Formal Presentation  
In Response  
To IDEQ Comment # 84

# ***ICDF Evaporation Pond Lining System Equivalency***

*Presented To:  
BBWI, IDEQ, EPA*

*November 13, 2001*

Figure 1-1. Evaporation Pond Lining System Sections.

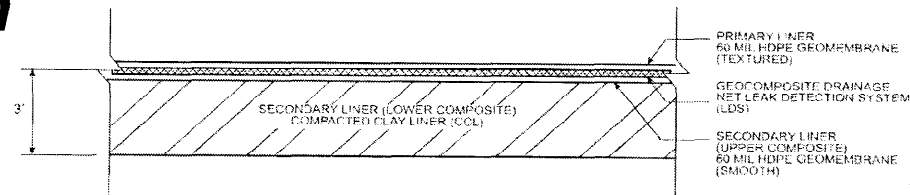
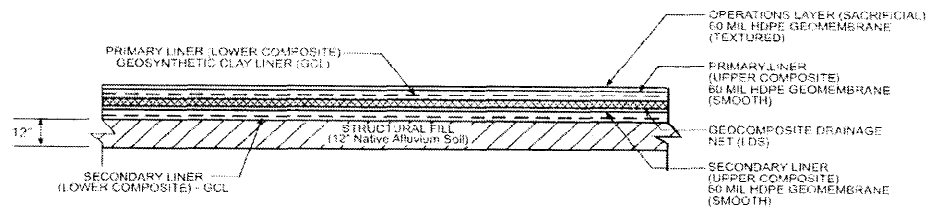
# ***Equivalency Analysis for Recommended Alternative***

- ***Standard Design (40 CFR 264.221)***
- ***Alternative Design***
